**ADDENDUM #1**

TO: PROSPECTIVE BIDDERS  
RE: GP 1103, Mahoning Rd. Corridor Project, PID 90361

**City Standard Drawing No. 43:** Tree grate detail modified. The new standard drawing (Revision 4/2014) replaces original drawing.

**City Standard Drawing No. 65:** Foundation detail has been modified. The new standard drawing (Revision 4/29/14) replaces original drawing.

**STANDARD DRAWING NO. 65**

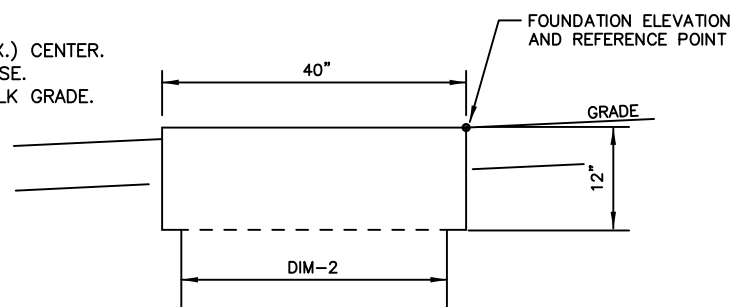
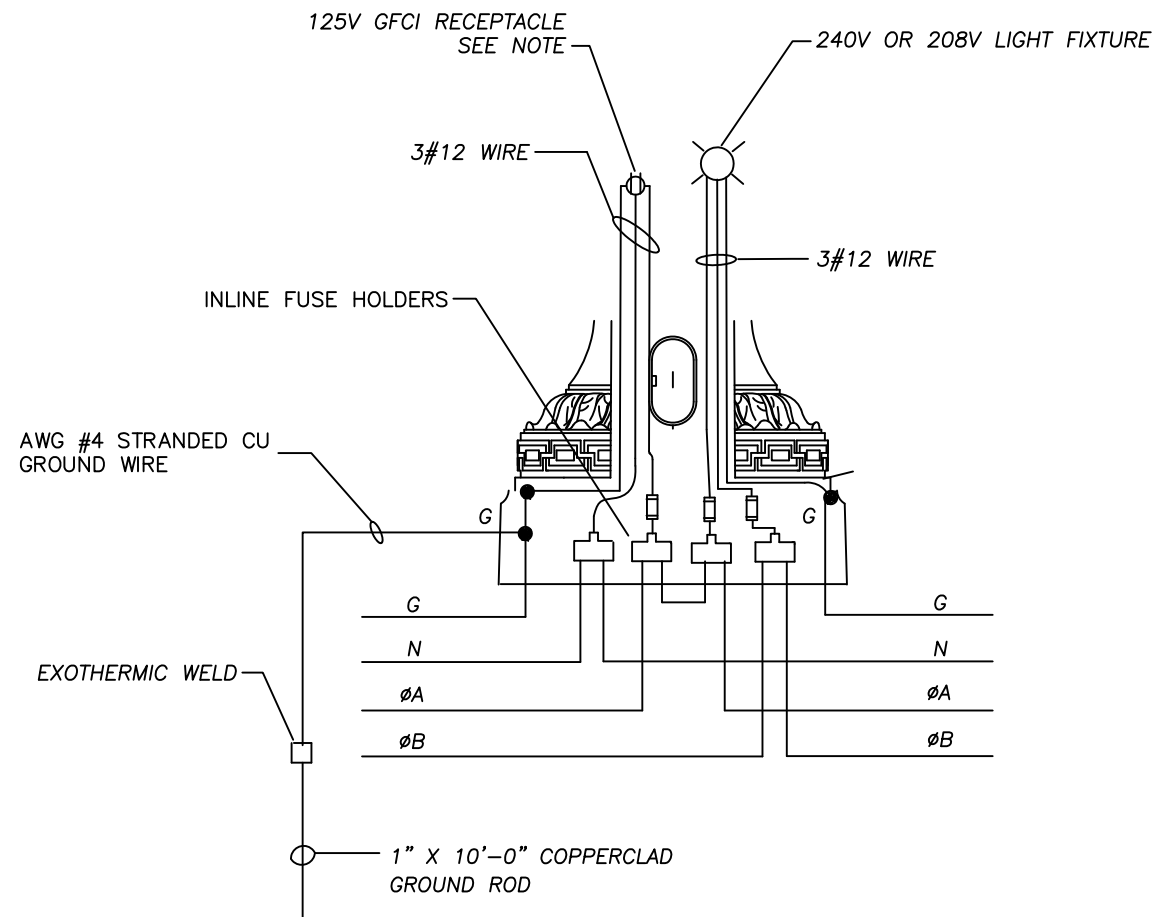
The City will allow pre-cast foundations for Item 625 – Light Pole Foundation, 30” x 72” Deep. The Contractor is responsible for constructability at each location.

DESCRIPTION	DATE	BY
MODIFIED DIMS AND OTHER CHANGES	4/29/14	NJL
